June 13, 2017 Revised

*Re: Addendum to Alternatives Analysis and Remedial Work Plan
Future Love Road Development Site (BCP Site C314113)
Poughkeepsie, Dutchess County, New York
Chazen Job #81434.00*

Figure 1 showing soil cover area

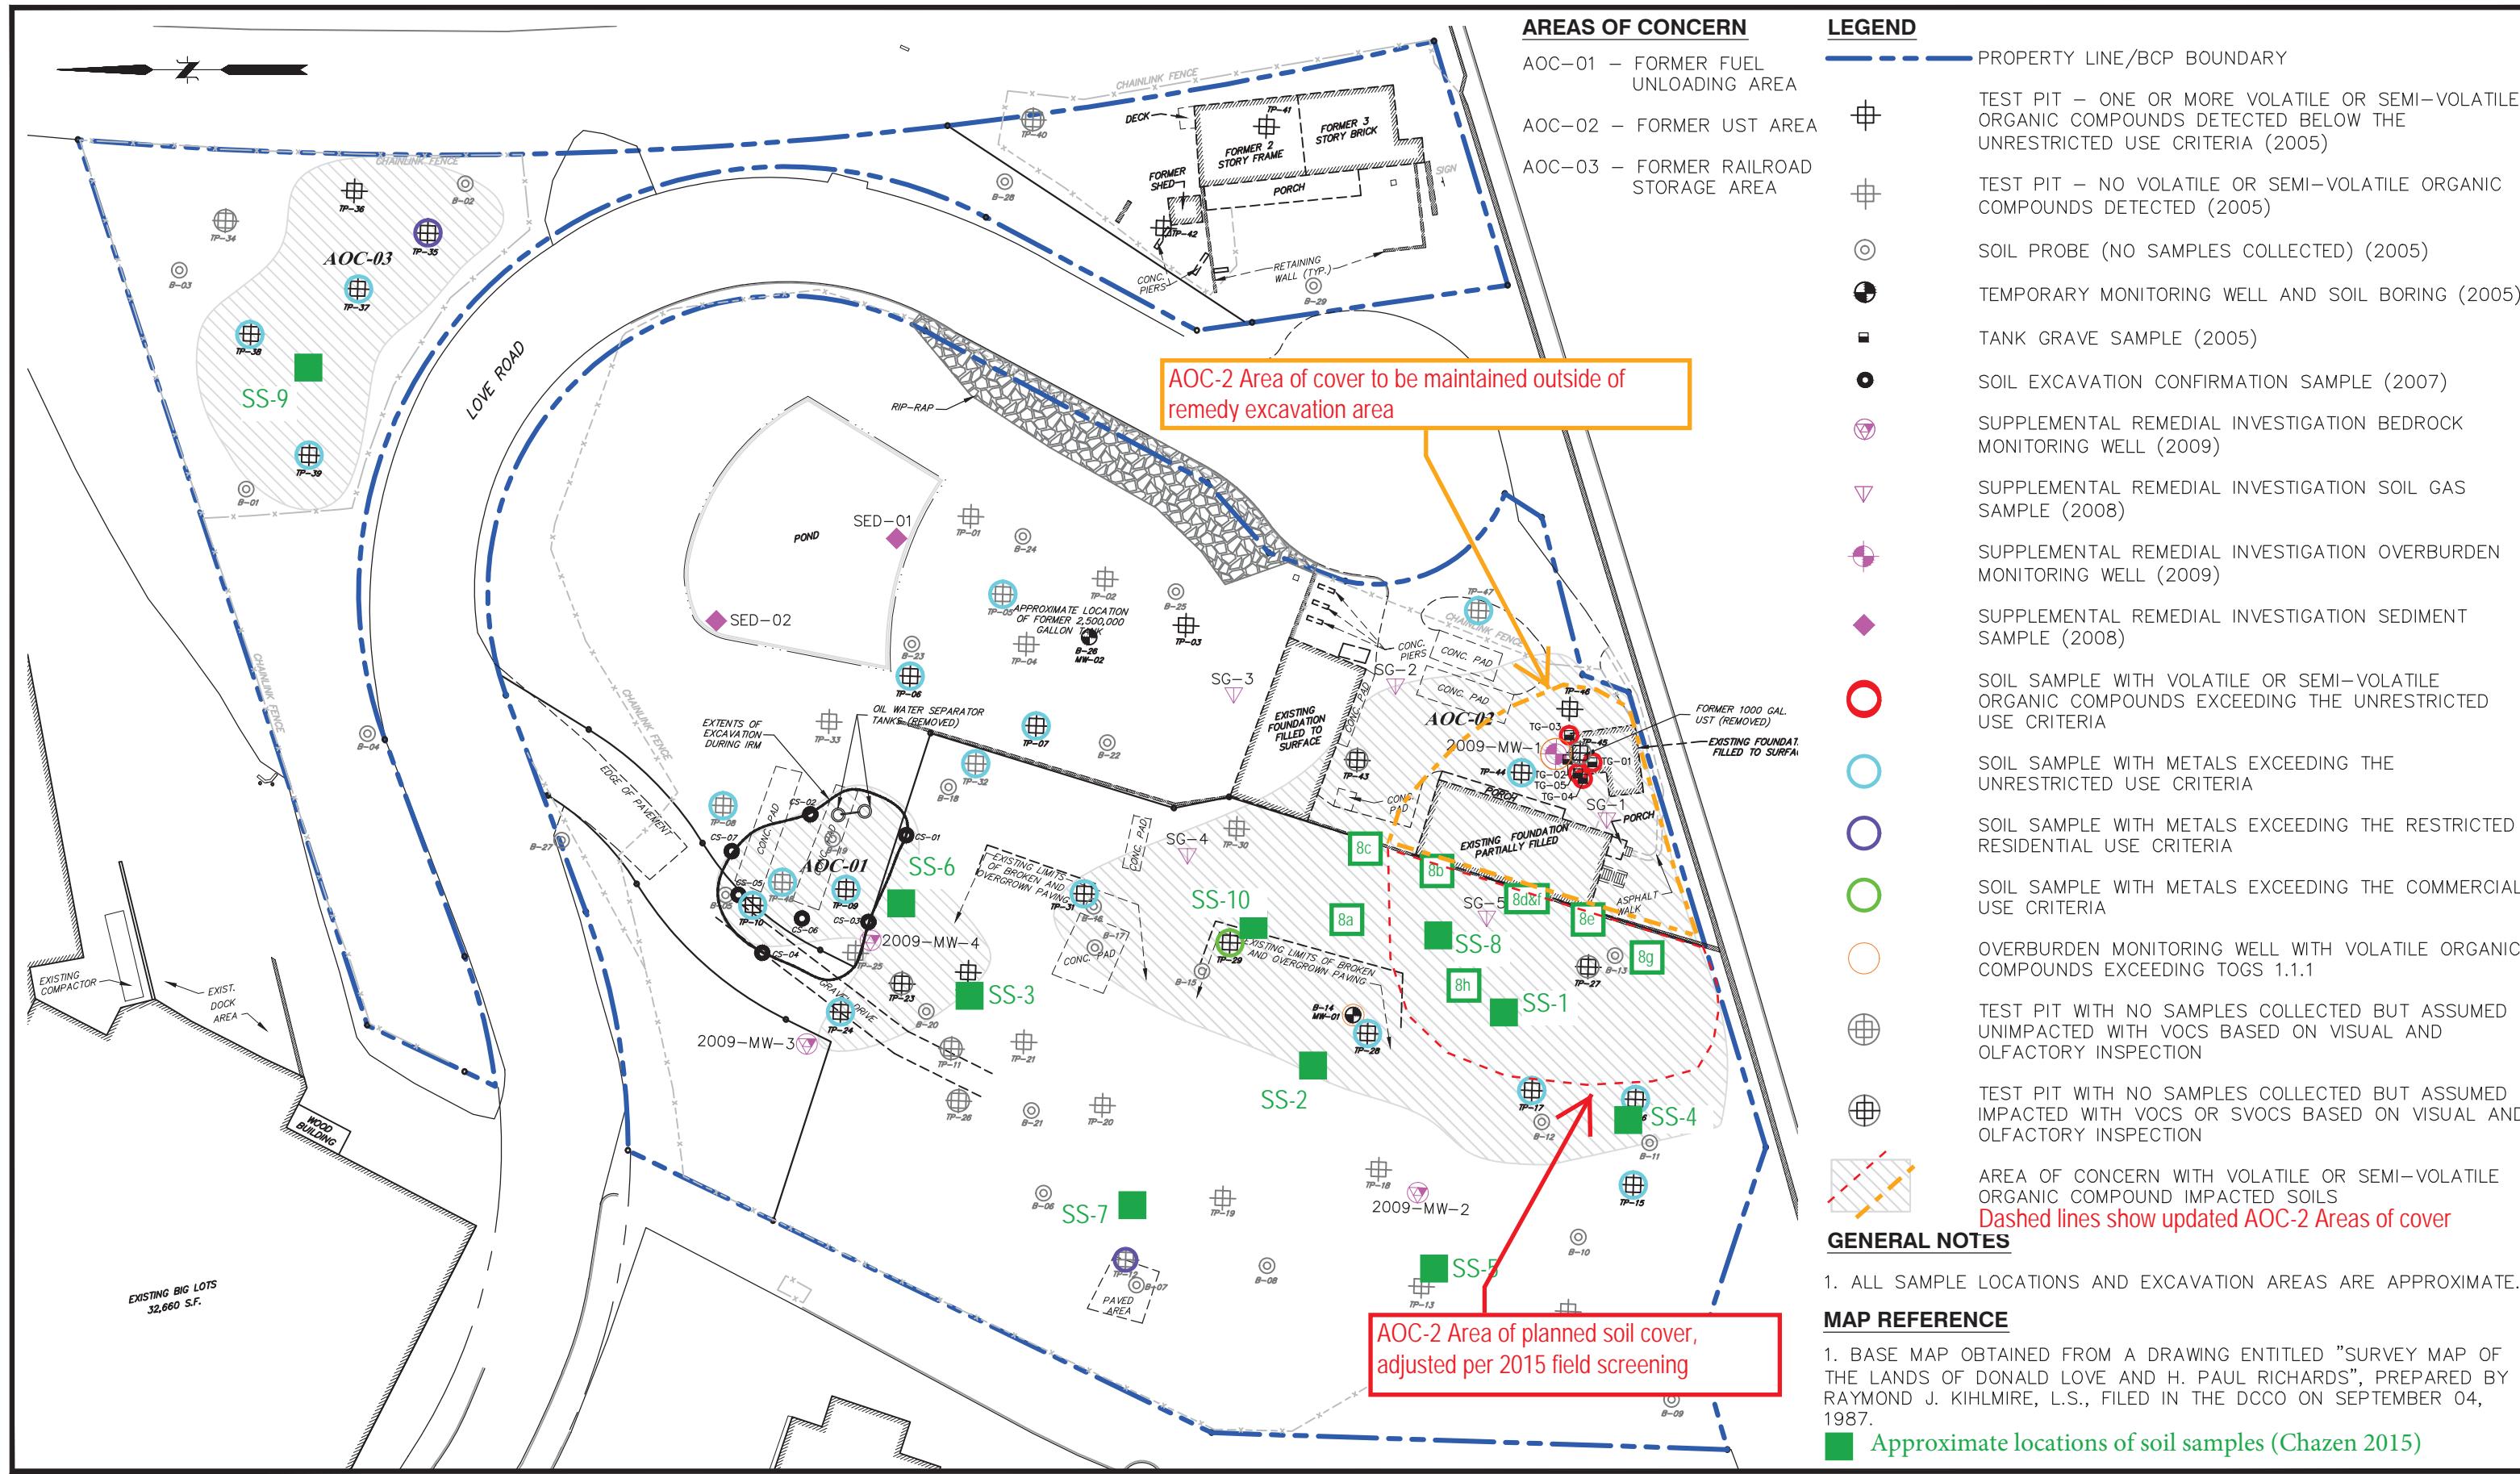
Based on Chazen's November 30, 2015 Supplemental Sampling investigation at the above-referenced site, this Addendum to the July 2012 *Alternatives Analysis and Remedial Work Plan* is provided to confirm the areas for the planned remedy. Soil cover is not needed in AOC-1 or AOC-3. A two-foot thick soil cover is planned for the AOC-2 area indicated by the dashed red line shown on **Figure 1**. To confirm that imported soil is acceptable for placement on the site, the proposed imported soil will be sampled consistent with DER-10 table 5.4e (below) to confirm that it meets Restricted-Residential SCOs, and a completed *Request to Import/Reuse Fill or Soil* form will be submitted to you with the sampling results. One field duplicate will be collected and analyzed for the same suite, and one trip blank will be analyzed for VOCs only.

Prior to soil cover placement, vegetation will be cleared from this area, and orange construction fencing placed as a demarcation layer. Then the two-foot thick soil cover layer will be installed and the area will be surveyed to document the remedy installation and soil cover thickness relative to an existing topographic survey. This information will be used to prepare the Final Engineering Report, and be included in the Environmental Easement. Erosion and sediment control measures will be in place, as required.

In addition to the soil cover, soil excavation work is also planned for the area of the former 1,000-gallon underground storage tank. This work is expected to be conducted consistent with Sections 6.5 through 6.7 of the July 2012 *Alternatives Analysis and Remedial Work Plan*. It is anticipated that 650 cubic yards of grossly contaminated soil will be removed from this location, with oversight and field screening for gross impacts and volatile organic compounds (VOCs) to confirm the final excavation limits. Confirmation soil samples will be collected and analyzed for VOCs and compared to Restricted-Residential Use SCOs to demonstrate that this remedy has met its objective. The NYSDOH Community Air Monitoring Plan will be implemented with periodic work area monitoring during excavation and handling of impacted soil. Excavation backfill will either be part of the fill material discussed above or, if from another source, will go through the same soil import approval process. As part of the remedy, the area outside around this excavation will have a cover retained/maintained (see orange dashed line on attached **Figure 1**).
